Cockle Bay Park Redevelopment State Significant Development Application (SSD DA) Stage 2

MOD-1 Envelope Modifications Proposal

Prepared for DPT Operator Pty Ltd and DPPT Operator Pty Ltd
01.11.2021

Tower - Retail Pergolas

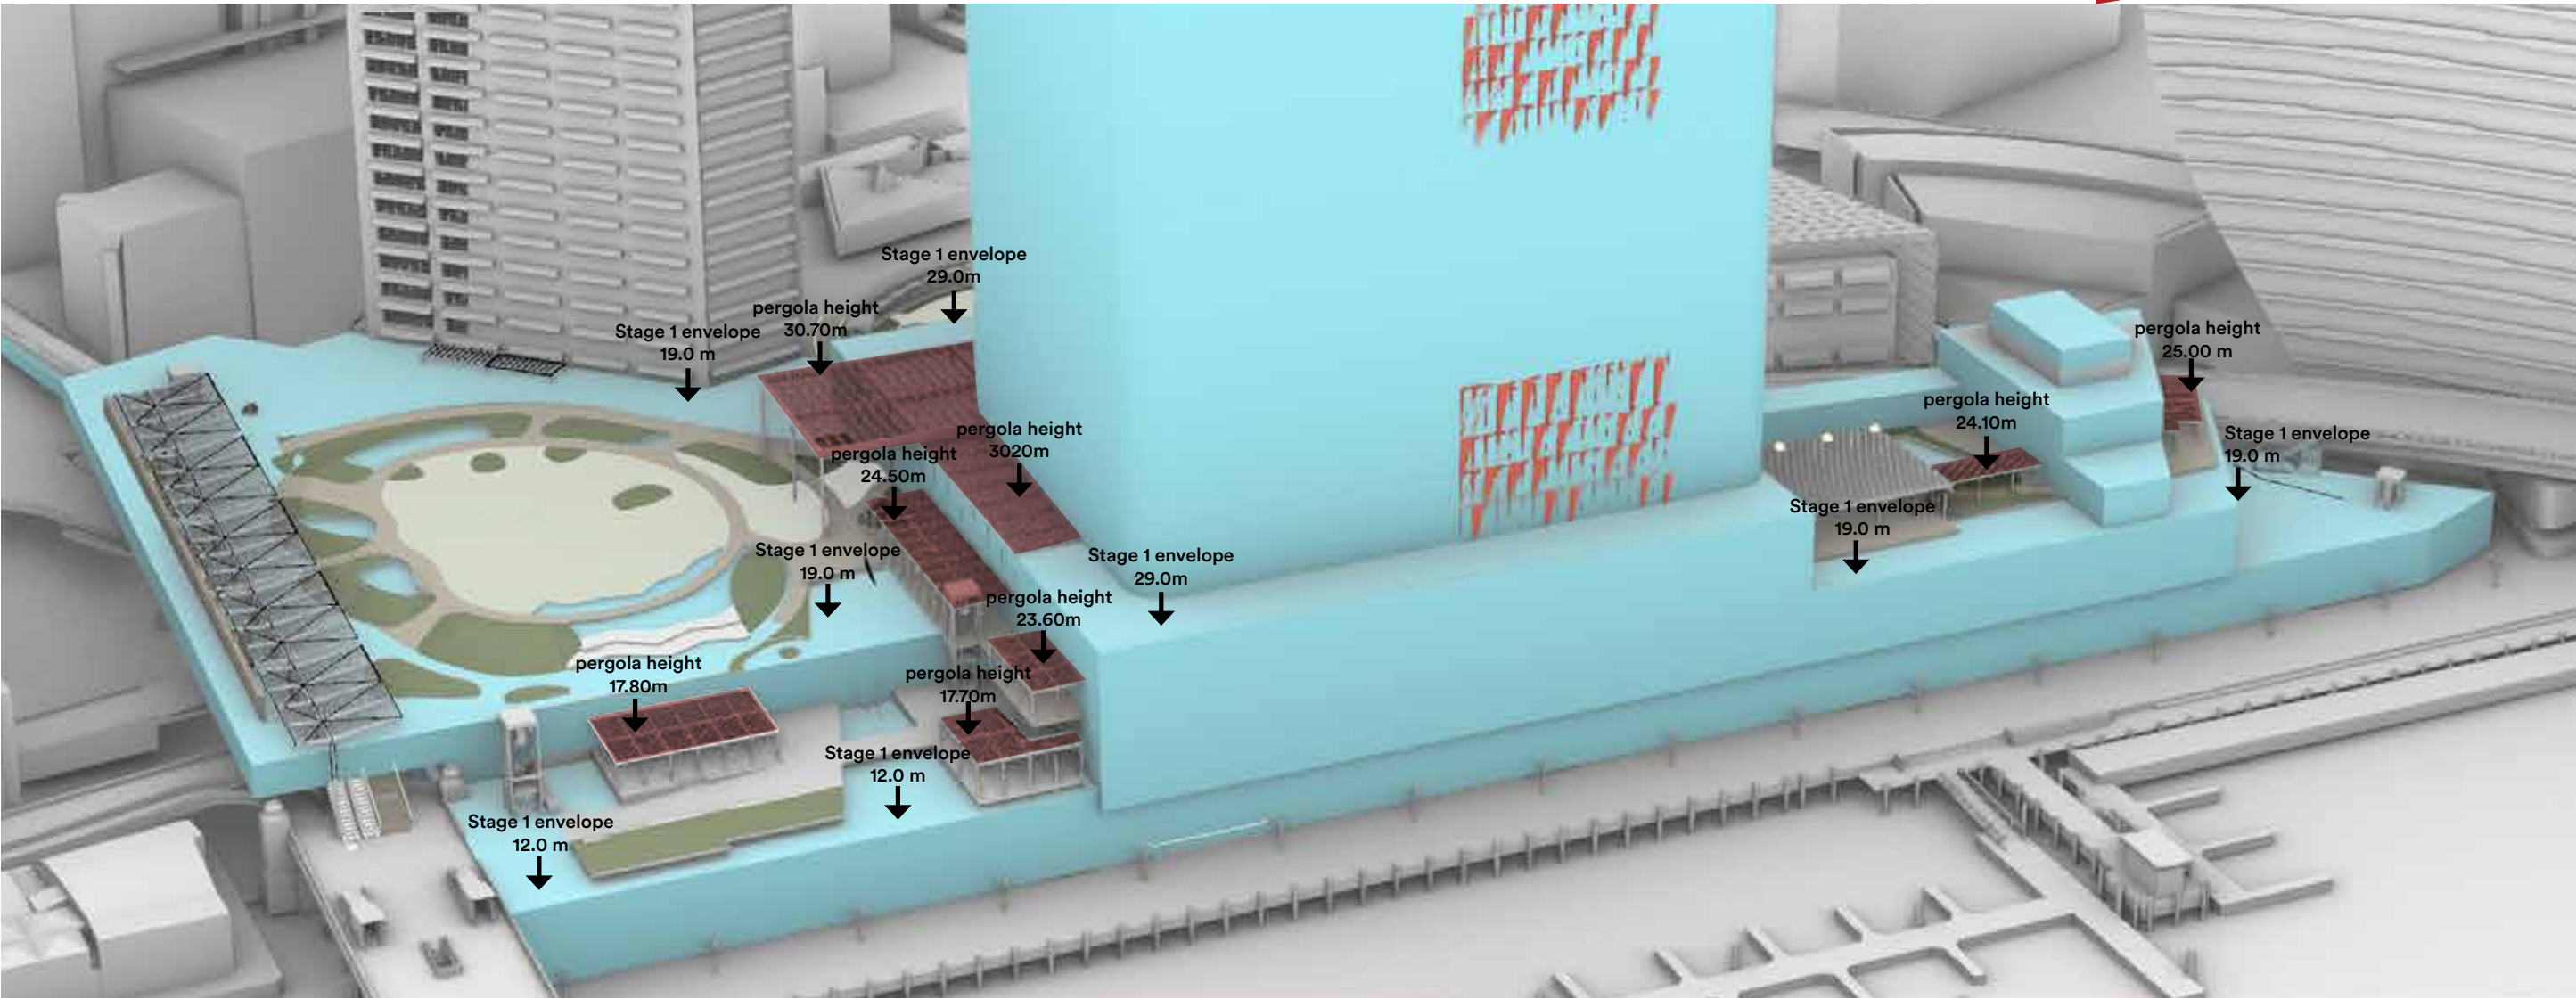
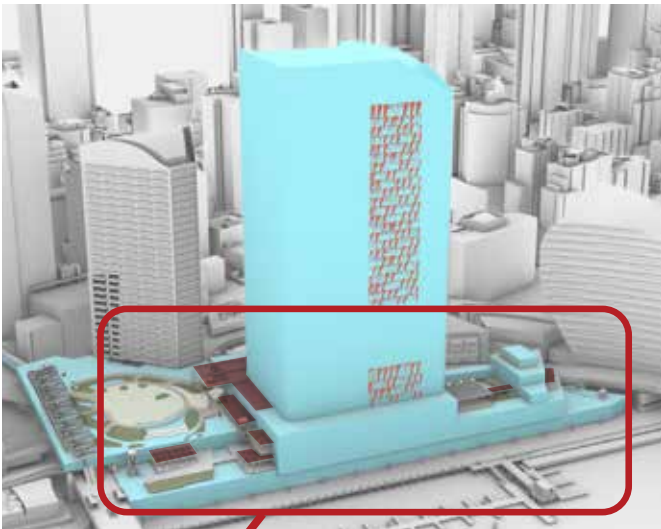
The Concept (Stage 1) DA permits garden pavilions and kiosks beyond the building envelope where these components are within, and relate specifically to, the publicly accessible open space or the public domain. The proposed pergolas are associated with the northern and southern park spaces and, therefore, are aligned with publicly accessible open space and public domain areas. In the case of the pergolas within the public domain, these refinements, therefore, would fall within the permitted exemptions and are appropriate and supportable.

Other pergolas around the base of the Tower provide much needed solar shading and climate comfort to external areas. They also shelter vertical transport elements, such as escalators, from the rain. The pergolas close to the Tower help to reduce down draught from winds around the Tower.

Compliance Clarification: Tower (West)

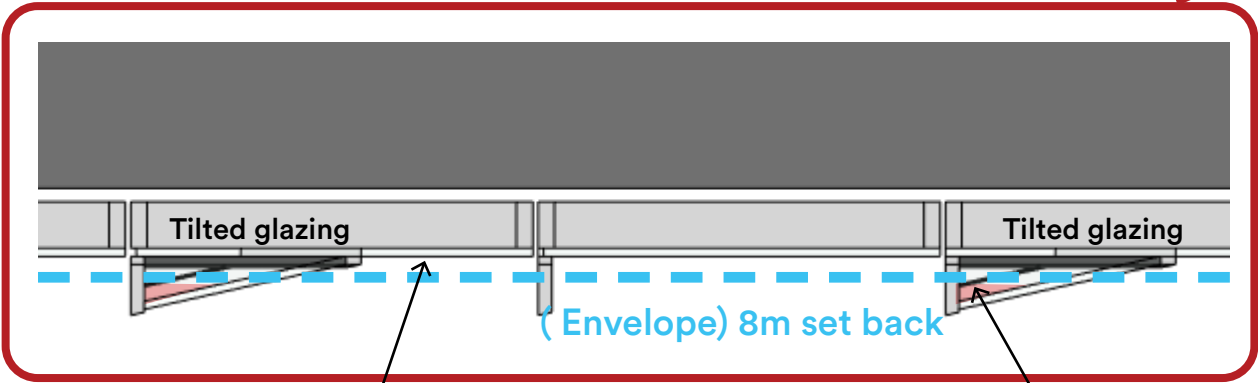
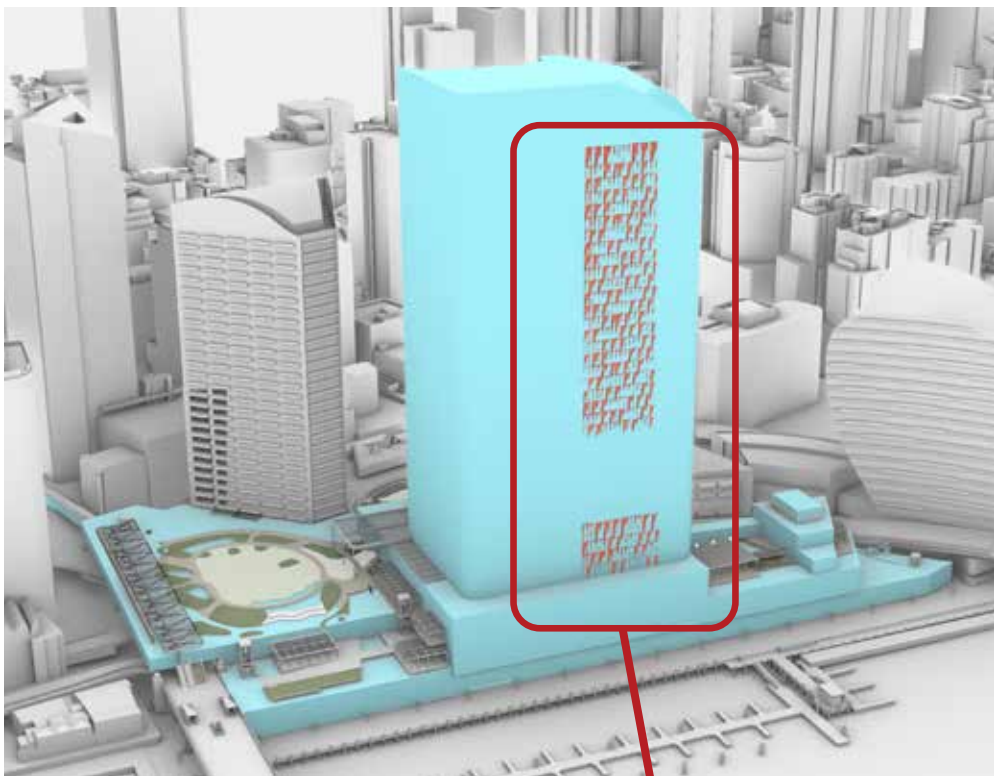
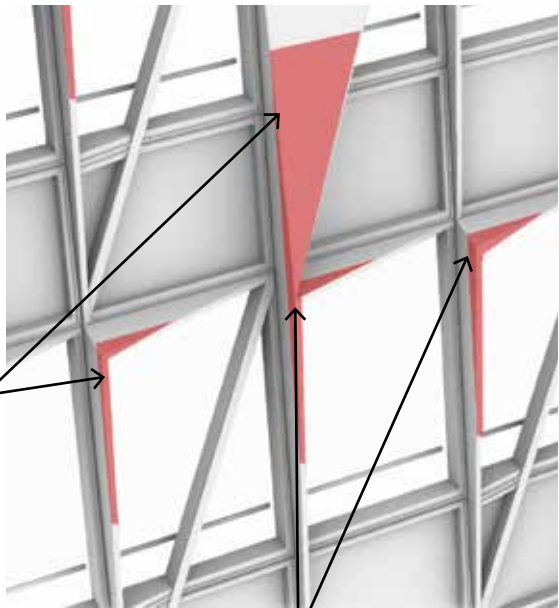
Currently in the the Western facade, a small portion of the facade articulation elements extend outside the envelope.

The proposed Tower facade elements that extend past the envelope are minor and variable, and do not constitute GFA. This articulation of the facade is an improved design outcome, optimises modulation of the facade elements and reduces heat gain in the tower.

The main glazing line lies within the envelope

Tilted glazed panels extend outside envelope slightly

Facade's shading elements extend through the envelope by approx. 200mm

Aluminium inclined triangulated opaque infill spandrels slightly outside the envelope.

Compliance Clarification: South Landscaping

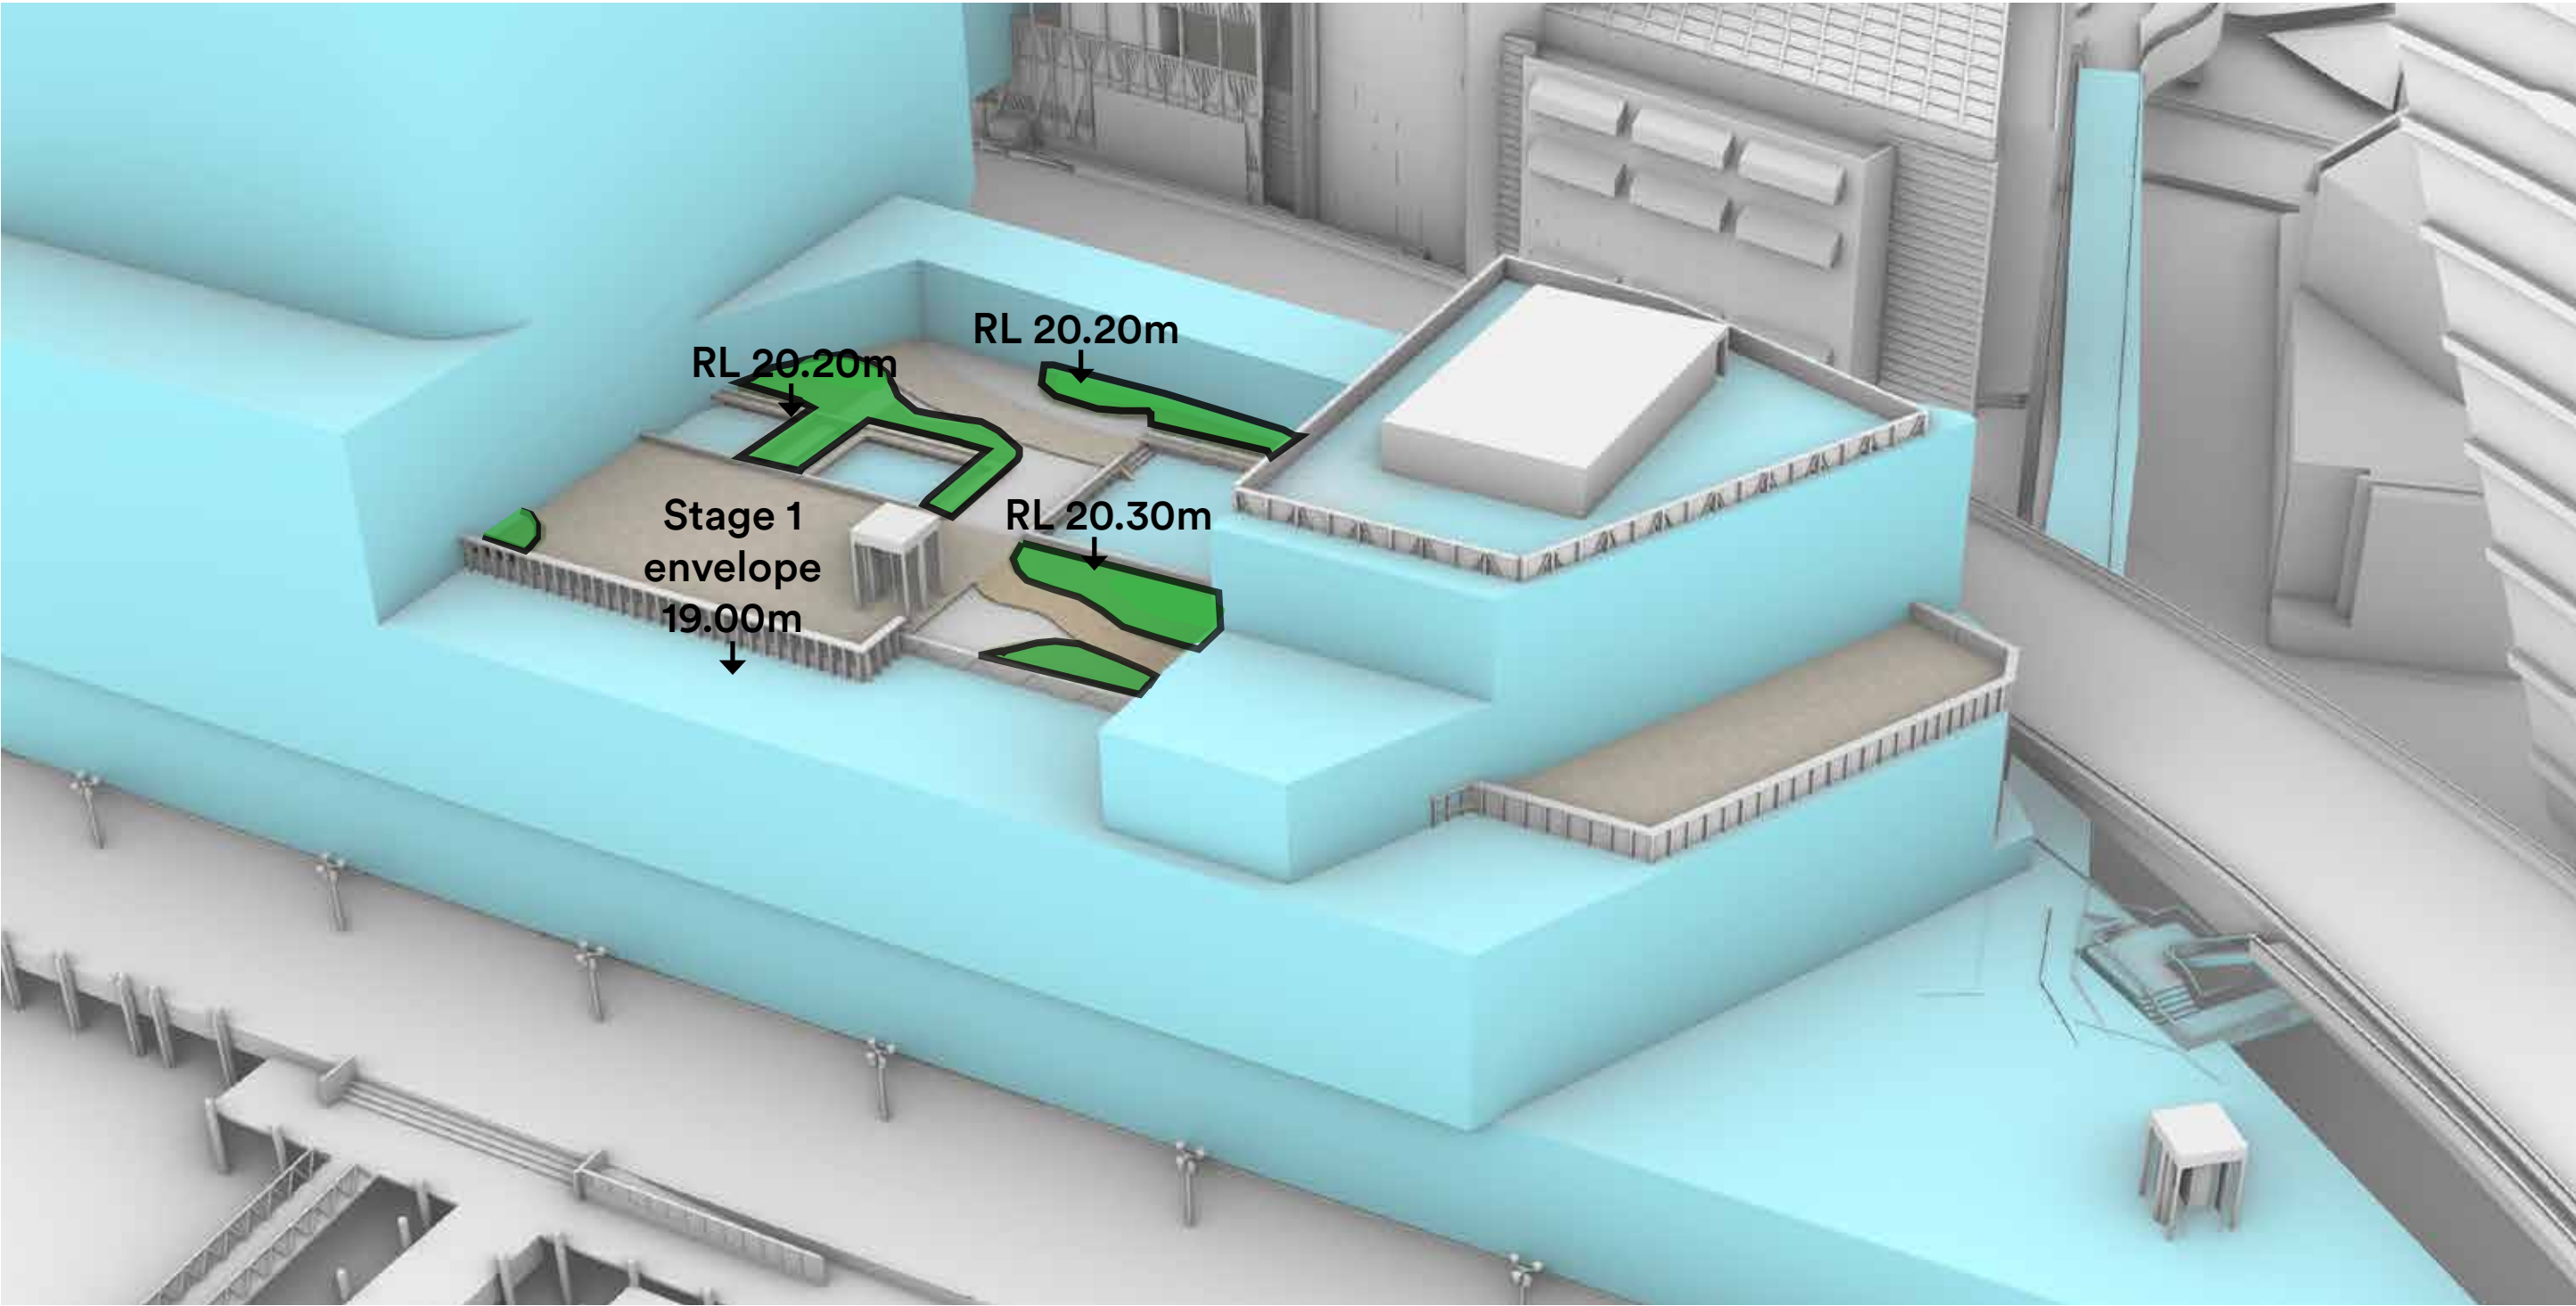
The Concept (Stage 1) DA permits balustrades(parapets) and vegetation to extend beyond the building envelope where these components are within, and relate specifically to, the publicly accessible open space or the public domain. Those components of the level change that solely relate to the build-up of soft materials for vegetation would comply within the permitted exemptions.

Compliance Clarification: North Landscaping

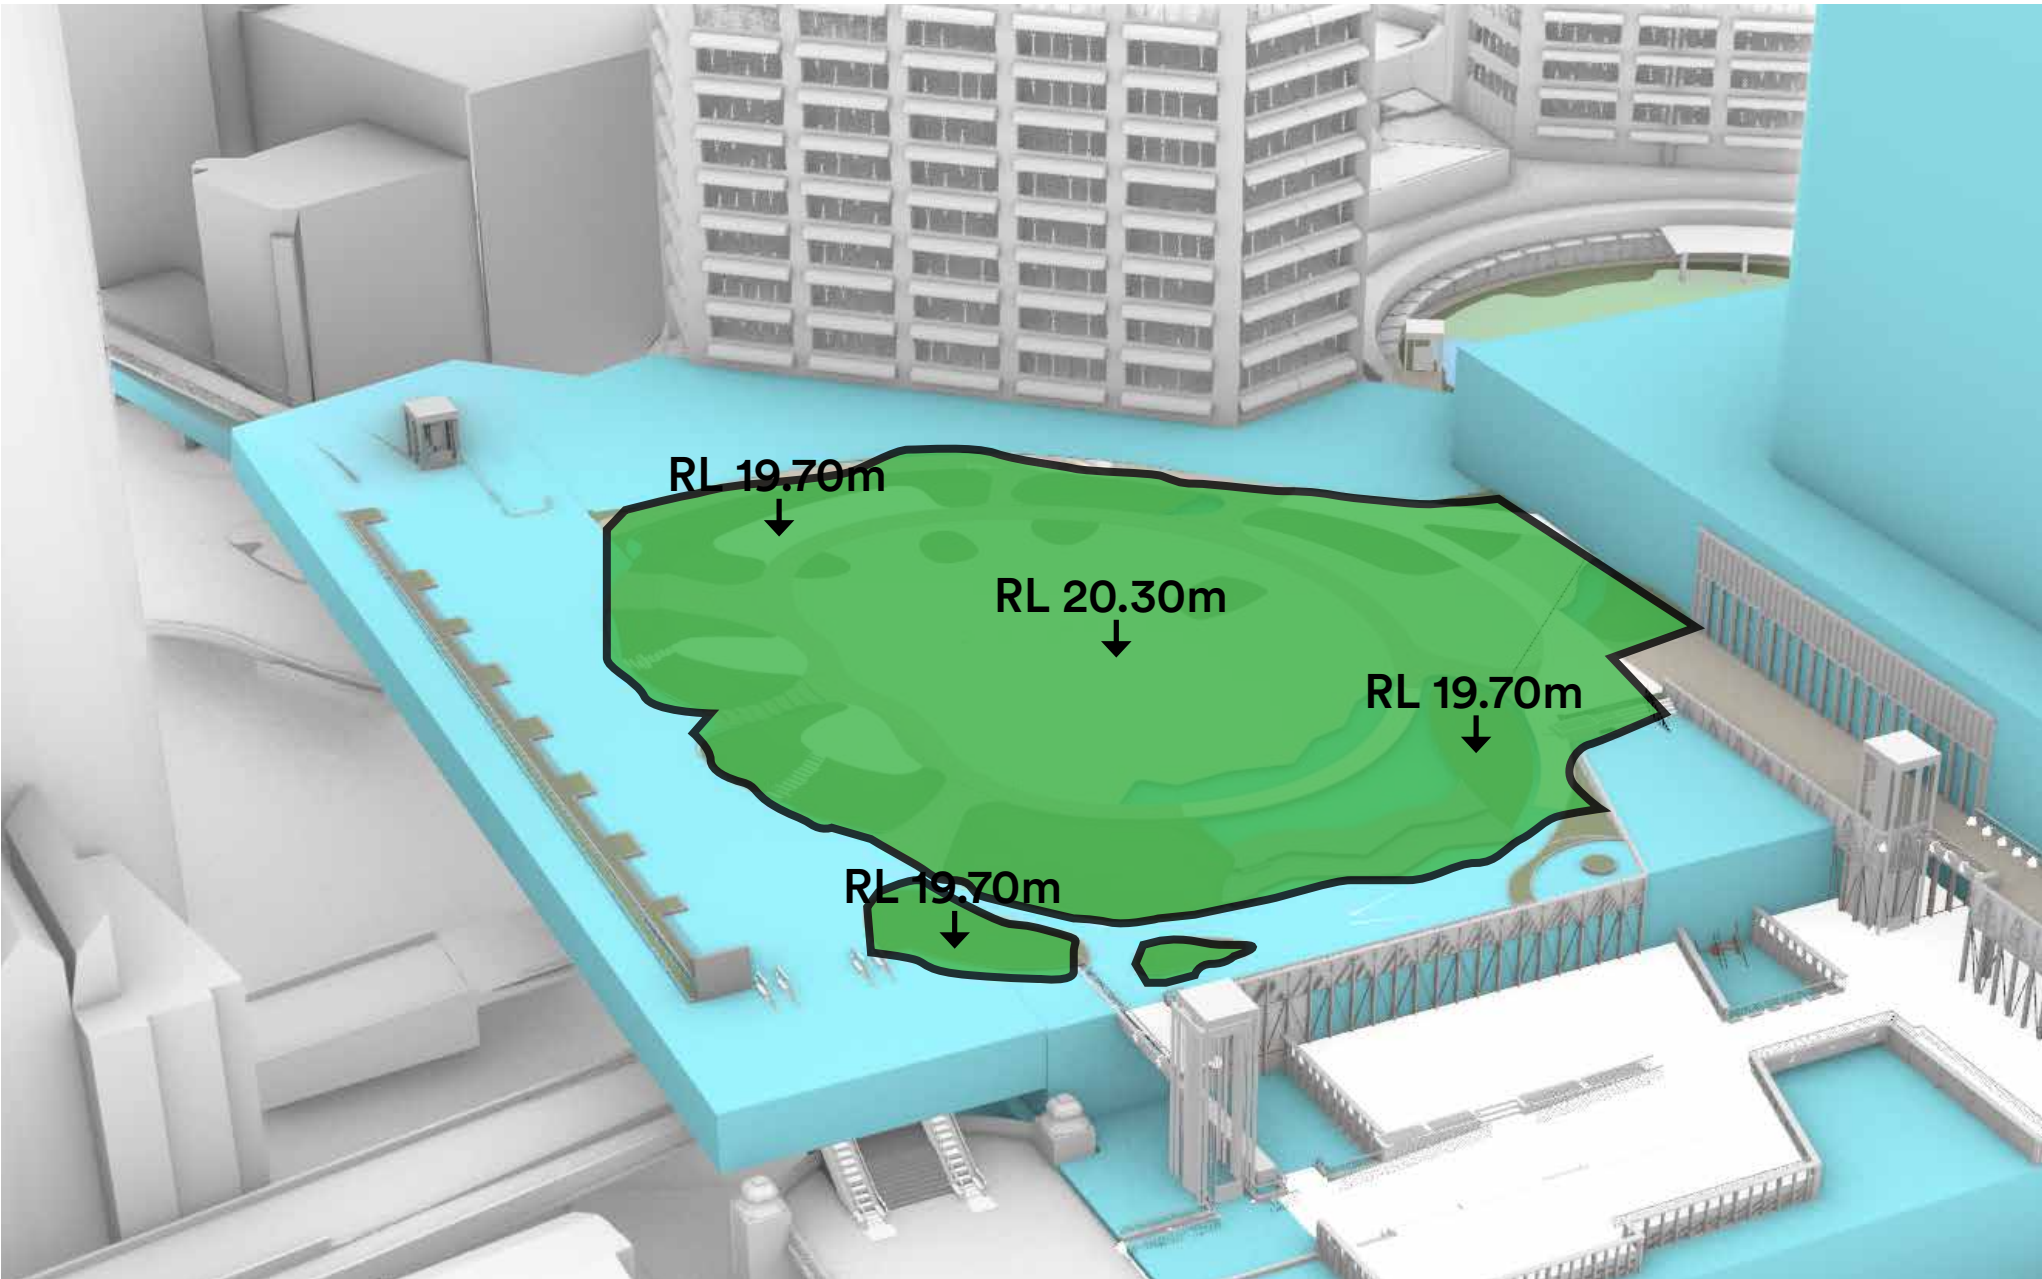
The Concept (Stage 1) DA permits balustrades(parapets) and vegetation to extend beyond the building envelope where these components are within, and relate specifically to, the publicly accessible open space or the public domain. Those components of the level change that solely relate to the build-up of soft materials for vegetation would comply within the permitted exemptions.
